Access Compliance Report

Public Rights-of-Way

(Curb Ramps)

Intersection ID: 6174	Main Street: IRISH_MOSS_LN	Cross Street: MINTLEAF_DR	Location: S
ADA ID: DADBDEF7FC69	Ramp Type: Perp	Initial Pass/Fail: Fail	Overall Compliance: No
Severity Score: 10			
Codes/Mitigation Info/Possible Solution		Field Measurements/Component Compliance

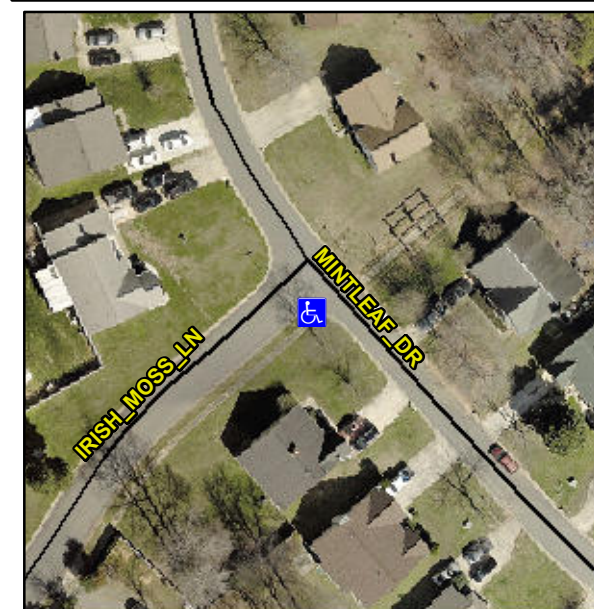
R304.5.1, R304.5.3

Compliance	Description	Data	Compliance	Description	Data
N/A	Ramp Length (in)	23.0	Yes	Ramp Slope (%)	7.8
No	Ramp Width (in)	46.0	No	Ramp XSlope (%)	3.6
N/A	Flare Type LT	N/A	N/A	Flare Type RT	N/A
N/A	Flare Slope LT (%)	N/A	N/A	Flare Slope RT (%)	N/A
N/A	Flare Traversable LT?	N/A	N/A	Flare Traversable RT?	N/A
N/A	Landing Length (in)	N/A	N/A	DWS Provided?	N/A
N/A	Landing Width (in)	N/A	N/A	DWS Contrast?	N/A
N/A	Landing Slope (%)	N/A	N/A	DWS Length (in)	N/A
N/A	Landing X Slope (%)	N/A	N/A	DWS Full Width?	N/A
N/A	Landing Curb? (Y/N)	N/A	N/A	DWS Offset (in)	N/A
N/A	Shared Landing?	N/A			
N/A	Gutter Ponding?	N/A	N/A	Gutter Slope (%)	N/A
N/A	Gutter Lip Ht (in)	0.5	N/A	Gutter X Slope (%)	N/A
N/A	Painted X Walk1?	No	N/A	Painted X Walk2?	N/A
	X Walk 1 Direction	To W		X Walk 2 Direction	N/A
N/A	X Walk 1 Width (in)	N/A	N/A	X Walk 2 Width (in)	N/A
	X Walk 1 Slope (%)	8.3		X Walk 2 Slope (%)	N/A
	X Walk 1 X Slope (%)	2.5		X Walk 2 X Slope (%)	N/A

Remove & Replace Entire Ramp.
